Subject [**Modification concerning the belt on evacuation tumble dryers.**]

We would like to inform you that we have introduce on to production of evacuation tumble dryers a new elastic belt code number 416001600 (item on exploded view A290) from week 14/96 (1st April 96) on all models of evacuation tumble dryers:

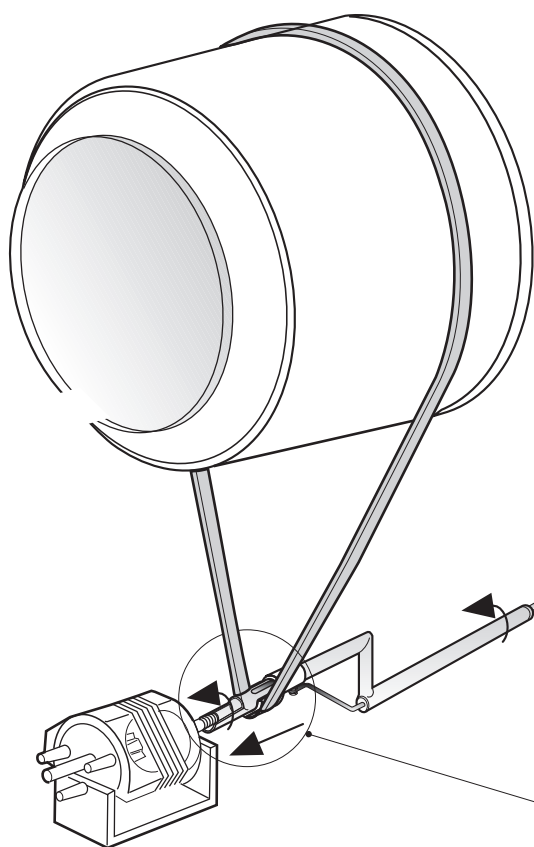
For information, we can use the new elastic belt also on the old models out of production removing the items that you can see on picture 1:

***** these parts together with the old belt must be removed if you use the new belt on the old products. We would like also to specify that the old items to fix the old belt will be always available like spare parts.
